CITY OF WISCONSIN DELLS MEETING AGENDA

Site Plan – Fiorella Neira
Columbia County, Wisconsin Dells Parcel 11291-436
Staff Report for Plan Commission, 11/13/2018

Re: Oak Street Development
City of Wisconsin Dells
Fiorella Neira – Owner
GEC #2-1018-499

PROPOSED GRADING PLAN
OAK STREET DEVELOPMENT
IORELLA NEIRA
 CITY OF WISCONSIN DELLS
 COLUMBIA COUNTY, WI

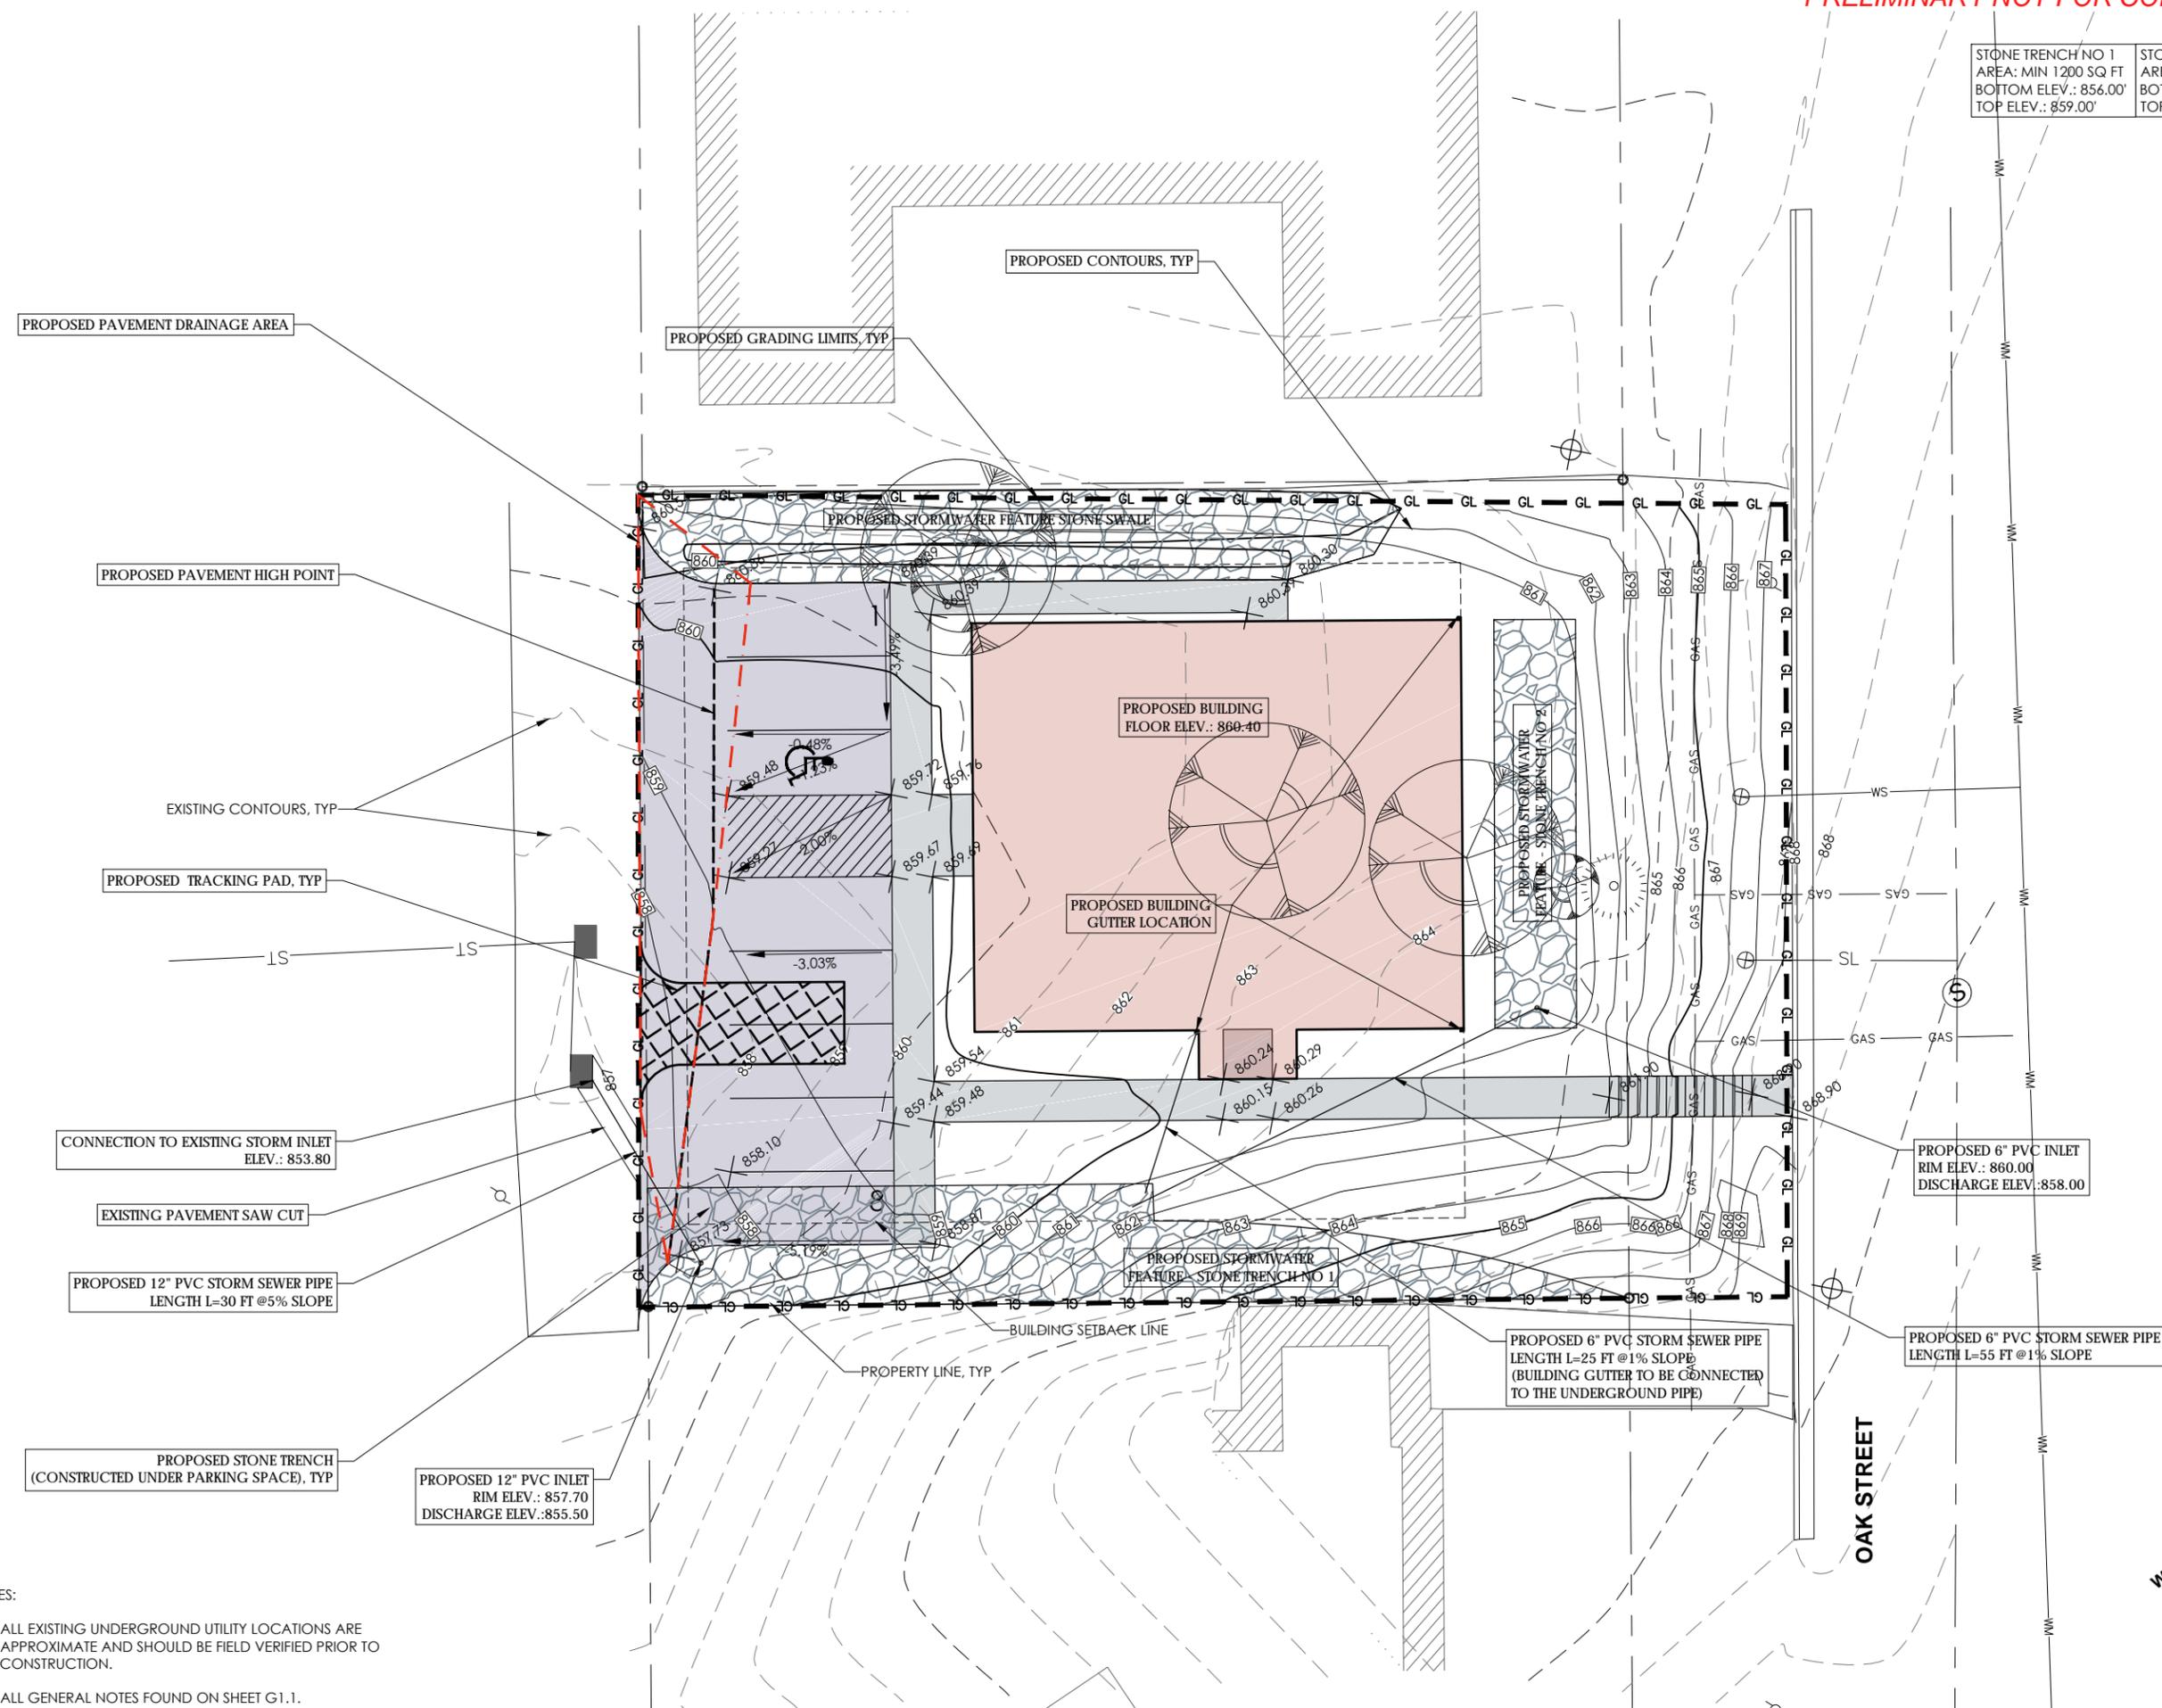
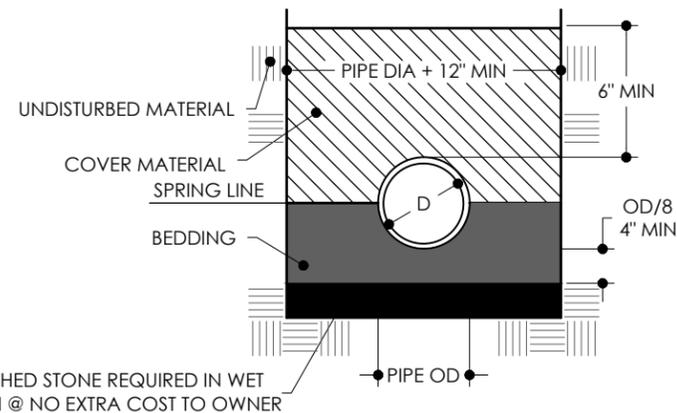
Required parking stalls must be paved, therefore a majority of this site, which is currently undeveloped and grassy, will become impermeable, which would likely increase the amount of storm water that will run off the site. The grade of this site had already created storm water issue for properties down-stream (west) which had required the City to rebuild the alley, storm sewer, and install two (2) storm water inlets in the alley adjacent to this site. The Plan from General Engineering includes three stone trenches that should be capable of holding back water for up to the 100 yr storm.

It appears this plan mostly address the storm water issue, however this is based on infiltration rates in the stone trenches. There is some concern about the infiltration rates decreasing over time. A pipe has been added as a backup discharge from the stone trench directly into the municipal storm water system. As this site has proven to provide some design challenges, minor tweaks to the system may be desirable. As such, this office requests final approval authority.

1. The final storm water system is approved by the Zoning Administrator.
2. The applicant obtains professional construction oversight.
2. The applicant cooperates with the City to address any parking, traffic flow, or storm water issues that may arise.
